# AGENDA

## NORTHERN BEACHES LOCAL PLANNING PANEL

**WEDNESDAY 2 FEBRUARY 2022**

4.1	DA2021/1522 - 189 Riverview Road, Avalon Beach - Demolition works and construction of a dwelling house	5
<b>5.0</b>	<b>NON PUBLIC MEETING ITEMS</b>	<b>94</b>
	A statutory Direction by the Minister of Planning and Public Spaces states the panel is only required to hold a public meeting where the development application has attracted 10 or more unique submissions by way of objection. There applications do not satisfy that criterion.

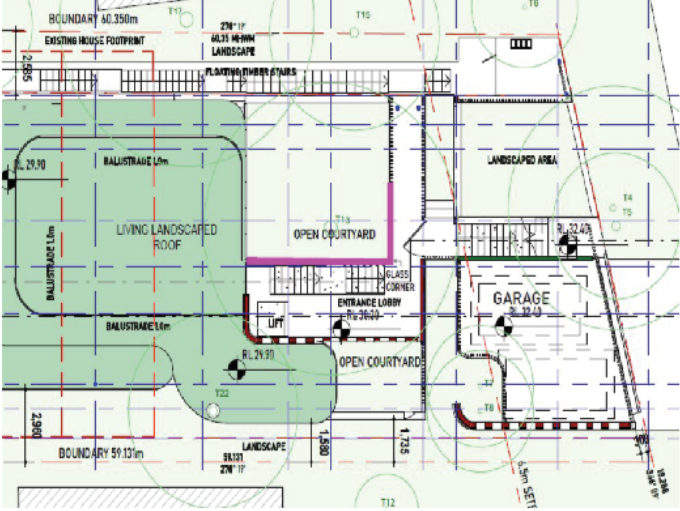
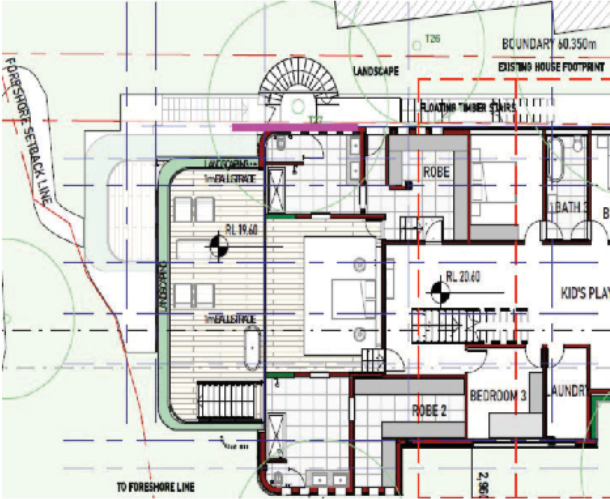
Internal Referral Body	Comments
	<p>including the appointment of a Project Arborist to supervise works, the impacts on these trees are manageable and can be supported.</p> <p>The two most significant trees located within the site, identified as Trees No. 13 and 27, have now been retained, with a number of tree root investigations taking place to determine the likely impacts of proposed works on existing root structures. Although this is seen as a positive, and it is clear work has been done to retain these trees, concern is still raised as these trees, in addition to Trees No. 7 and 8, fall within 2 metres of the proposed building. Should the plans be approved with the current layout, Trees No. 7, 8, 13 and 27 may all be removed without approval under the tree removal provisions outlined in control B4.22. The implications of this are significant as the total number of trees likely to be removed increases, including the two most value, biodiversity rich trees within the site. For this reason, it is recommended that further design alterations be made, ensuring that proposed works are at least 2 metres clear of proposed works to not only minimise impacts but also ensure they are retained in the long-term. The proximity of these trees to the proposed building can be seen in the image below:</p>  <p>It is noted tree root investigations have taken place adjacent to Trees No. 13 and 27; however, concern is raised as these tree root investigations do not appear to have been completed on the edge of proposed works. Hence, these investigations do not provide an accurate depiction of the existing roots and what is likely to be impacted by the proposed works. In order to ensure proposed works do not impact significant roots of these two trees, it is recommended that additional tree root investigations take place in the locations as depicted by the PINK line in the below images. Should design alterations be made to ensure greater clearance from these trees, the tree root investigations should take place on the edge of the proposed works, similar to that depicted in the below images:</p>

Internal Referral Body	Comments
	 <p>Required tree root investigation location for Tree No. 13.</p>  <p>Required tree root investigation location for Tree No. 27.</p> <p>In light of the above concerns, the landscape component is therefore not currently supported. It is recommended that an amended Arboricultural Impact Assessment be provided detailing the likely impacts of proposed works on Trees No. 4, 5, 7 and 8, with site specific tree protection measures recommended to ensure these trees are successfully retained and adequately protected. Should this investigation find proposed works are to have TPZ encroachments greater than 10% or any SRZ impact, further tree root investigations are required in accordance with AS4970-2009, specifically Clause 3.3.3 Major Encroachment. Additionally, it is recommended that an alternative design layout be sought ensuring that proposed buildings are located at least 2 metres from trees to be retained. This is particularly important for Trees No. 13 and 27. Following this, additional tree root investigations are required to take place in the locations depicted in the above images, or on the edge of proposed works. Should</p>

Internal Referral Body	Comments
	<p>these investigations determine no significant roots are found and no detrimental impacts on these trees is likely, the landscape component of the proposal could be supported subject to conditions of consent.</p> <p>Upon the receipt of the required information, further assessment can be made.</p> <p><b>Original Landscape Comments - 10/09/2021</b></p> <p>This application is for demolition of an existing residential dwelling, and the construction of a new residential dwelling, inclusive of a swimming pool, double garage and new landscape works.</p> <p>Councils Landscape Referral section has considered the application against the Pittwater Local Environmental Plan, and the following Pittwater 21 DCP controls:</p> <ul style="list-style-type: none"> <li>• B4.22 Preservation of Trees and Bushland Vegetation</li> <li>• C1.1 Landscaping</li> <li>• D1.14 Landscaped Area - Environmentally Sensitive Land</li> <li>• D1.20 Scenic Protection Category One Areas</li> </ul> <p>The Statement of Environmental Effects provided with the application notes that a number of trees are required to be removed in order to facilitate proposed works. This statement is largely supported by the Architectural Plans as it is evident a significant number of trees are proposed to be removed. It is further noted that an Ecology Report has been provided alongside the application, however an Arboricultural Impact Assessment has not.</p> <p>Generally, there a number of concerns raised with the proposal, largely relating to the removal significant, high value, native canopy trees, as well as the impacts of proposed works on those trees proposed to be retained. The Ecology Report provided has noted that a total of seventeen native canopy trees are to be removed, sixteen of which are from the Pittwater Spotted Gum Forest, an Endangered Ecological Community (EEC). Nine trees are proposed to be retained, all of which are located below the Foreshore Building Line. Two additional trees also appear to be retained within the road reserve at the front of the site.</p> <p>It is noted that a Pre-Lodgement Meeting was conducted for this site, with Biodiversity Advice recommending the redesign of the built form and site layout to ensure Trees No. 13 and 27 be retained. Tree No. 13 and 27 are of particular high value, and efforts should be made to retain these. Landscape comments also recommended that an alternative building layout be sought, particularly in the eastern portion of the site, preventing the removal of a number of significant native trees. It is evident that limited re-design has occurred, as both of these two high value trees, as well as trees towards the eastern boundary, are proposed for removal. Considering the bulk and scale of the building, it is recommended again that the site layout be re-visited, exploring opportunities to retain these two</p>

The project architect has prepared the below height blanket diagram taken at a height of 8.5m above ground level:

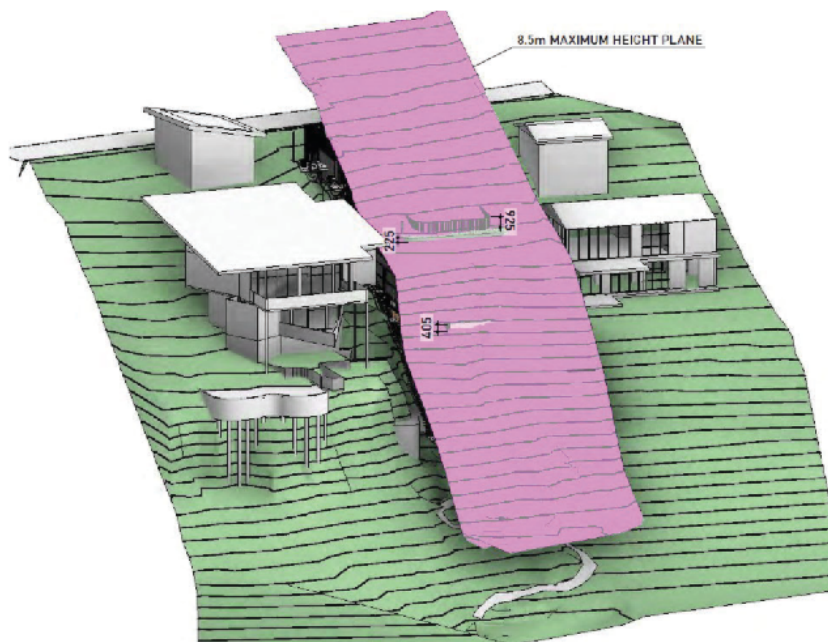
The extent of encroachment and the elements encroaching the 'blanket' in pink above are the elements subject of the below assessment, and those elements are considered to be minor.

**Figure 1: Building Height non-compliance shown in purple.**

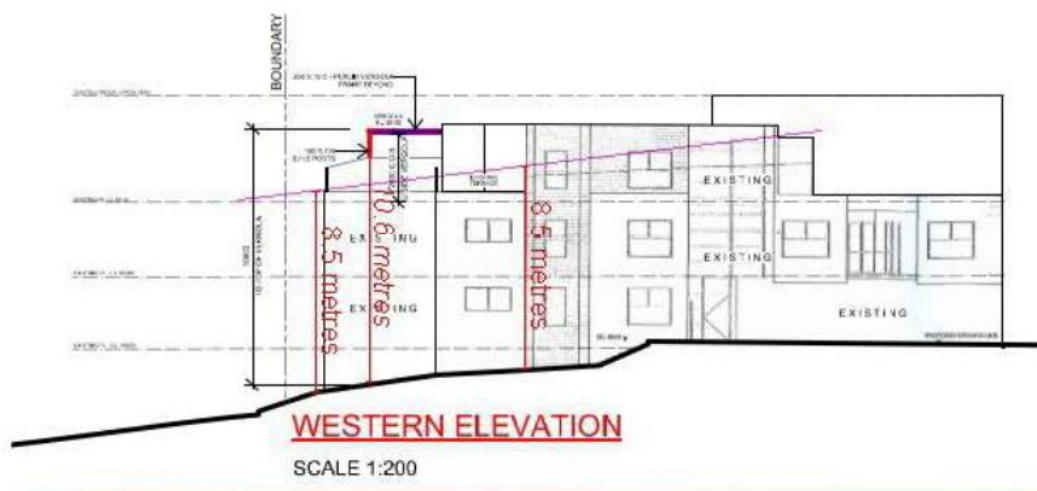
The land has an average gradient of 1:6 which influences the building height and roof elements that exceed the corresponding height plane. See figure below.

The proposal's building height continues to reflect the established built form character of the immediate Delmar Parade area where multi-level, and non-complying building heights are prevalent due to approvals under previous legislation and the steep topography of the land along this immediate area.

Image 1: Roof plan indicating setbacks from mechanical plant screening to eastern, western, northern and southern boundaries.

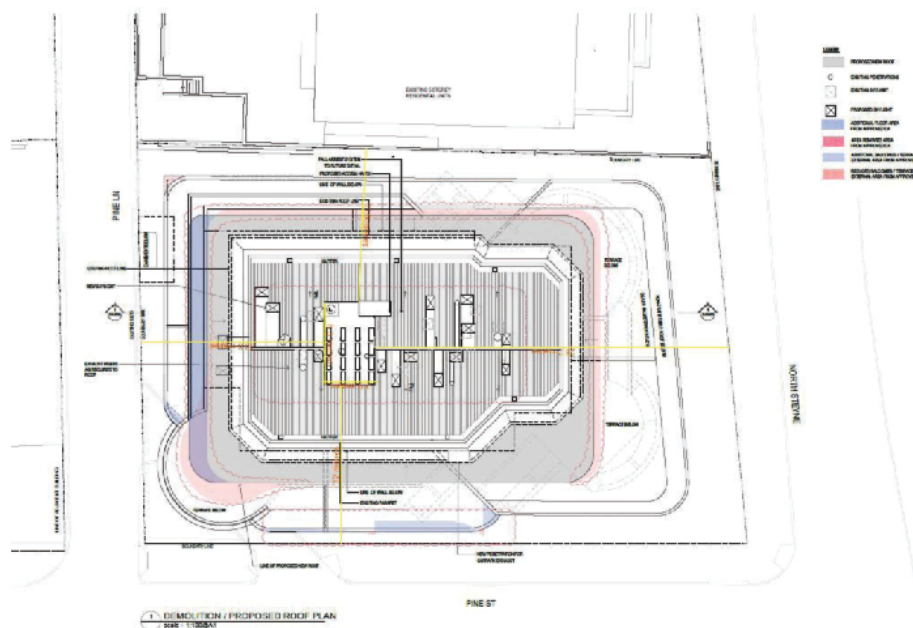
The application proposes mechanical plant with acoustic screening on the roof of the subject residential flat building. The mechanical plant and screening will measure a maximum height of 1.55m resulting in an overall building height of 16.45m (RL22.41). A condition is imposed in the consent to ensure that the highest point of the development does not exceed RL22.41 with the louvred screening in association

with the mechanical plant will not measure greater than 1.55m above the approved top of roof (RL20.79). Whilst the plant and screening exceeds the maximum 13.0m LEP height control prescribed for the site, the mechanical plant and screening will not be visible from a public place, with generous setbacks to the eastern, western, southern and northern boundaries. The residential flat building currently measures 14.9m in height with the previous application (DA272/2017) approving amendments to the roof form.

The non-compliant mechanical plant and screening is confined to a central portion of the roof and is considered to have a minimal impact towards the amenity of the surrounding properties and the appearance of the building when viewed from a public space.

- The mechanical plant louvred screening is limited to a maximum of 1.55m in height above the approved top of the roof (RL20.79) and is not to exceed an overall height greater than RL22.34.
- Delete the extension to the ground floor terrace for Unit 2 and Unit 3.
- Delete the proposed wall along the eastern boundary.
